PLANNING REPORT IN ACCORDANCE WITH SECTION 179 3(a) OF THE PLANNING AND DEVELOPMENT ACT 2000 (as amended)

Re: **Construction of a traffic management scheme comprising the following development works (as revised):**
Modified traffic lane widths along the N21 within Abbeyfeale town centre with revised parking layout;
New traffic signals junction controls and associated layouts will be installed at the Main Street/ Church Street and Main Street/ Colbert Terrace junctions with controlled pedestrian crossings on all arms of the proposed traffic signal junctions;
Upgrade of mini roundabout junction at Colbert Terrace/ Tesco access;
Provision of road widening at junction of Colbert Terrace and New Street, which involves demolition of one property;
New coach parking set downs on Main Street;
Provision of coach parking to rear of Main Street and modifications to Grove Crescent public car park;
Development of an uncovered pedestrian link between Main Street and Grove Crescent public car park requiring the modification of an existing building on Main Street;

Planning Reference No: 17/8019

Date: 29 March 2018

Figure 4: Proposed traffic management plan – as modified

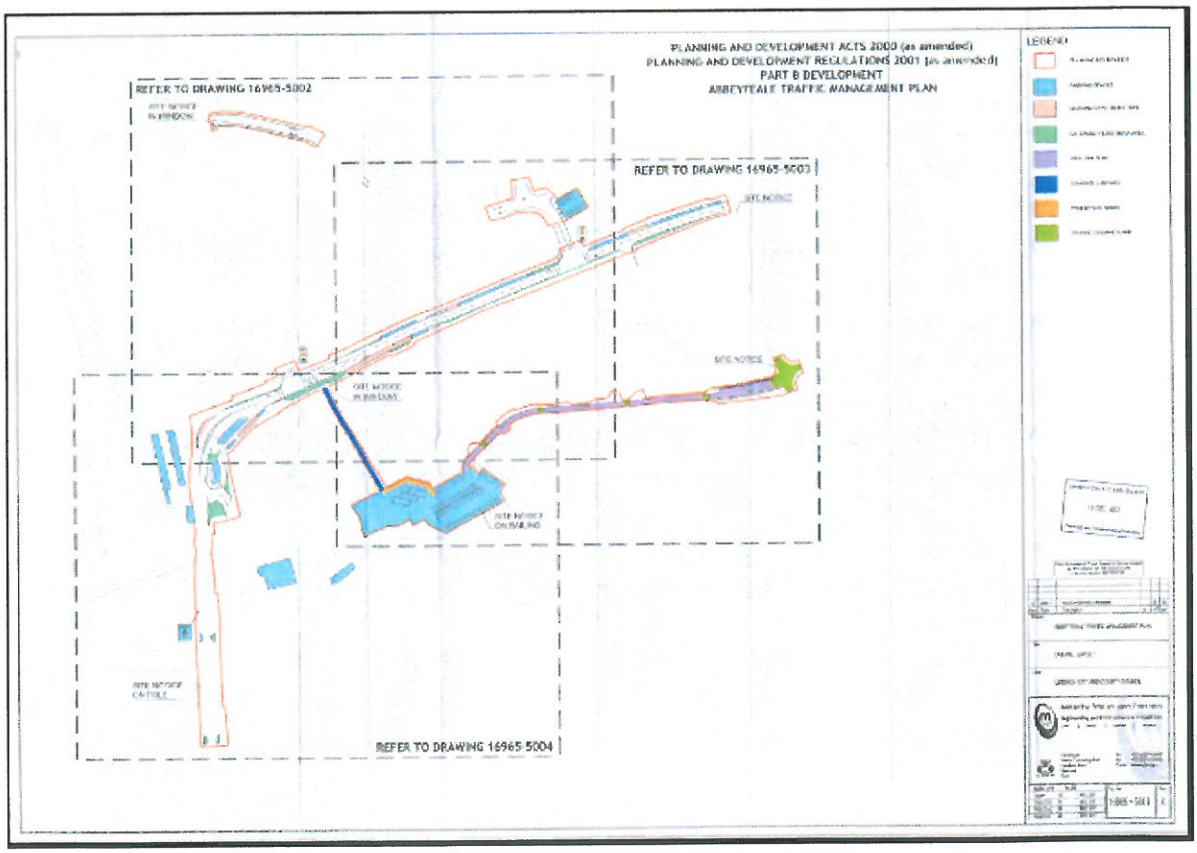
The site is zoned town centre in the Abbeyfeale Local Area Plan 2014 – 2020, and the N21 national primary route traverses the town and is the primary route from Limerick to Kerry. The town experiences high volumes of through traffic and local traffic daily. Following the public consultation day and the submissions received on the file, the traffic management plan was modified as follows:

- The proposed upgrade of the laneway at the rear of Main Street from Cedarville to Grove Crescent Car Park is being omitted from the scheme.
- The improvements to the roundabout at Tesco will be subject to detailed design and provided within the public space available.
- The wheel/tyre stop at the Car Park at the rear of McMahon Butchers will be subject to detail design.

The Abbeyfeale Traffic Management Plan has been modified as per drawing number 16965-5013 Rev C as follows: -

- Modified traffic lane widths along the N21 within Abbeyfeale town centre with revised parking layout.
- New traffic signals junction controls and associated layouts will be installed at the Main Street /Church Street and Main Street /Colbert Terrace junctions with controlled pedestrian crossings on all arms of the proposed traffic signal junctions.
- Upgrade of mini roundabout junction at Colbert Terrace/Tesco access.
- Provision of road widening at junction of Colbert Terrace and New Street, which involves demolition of one property.
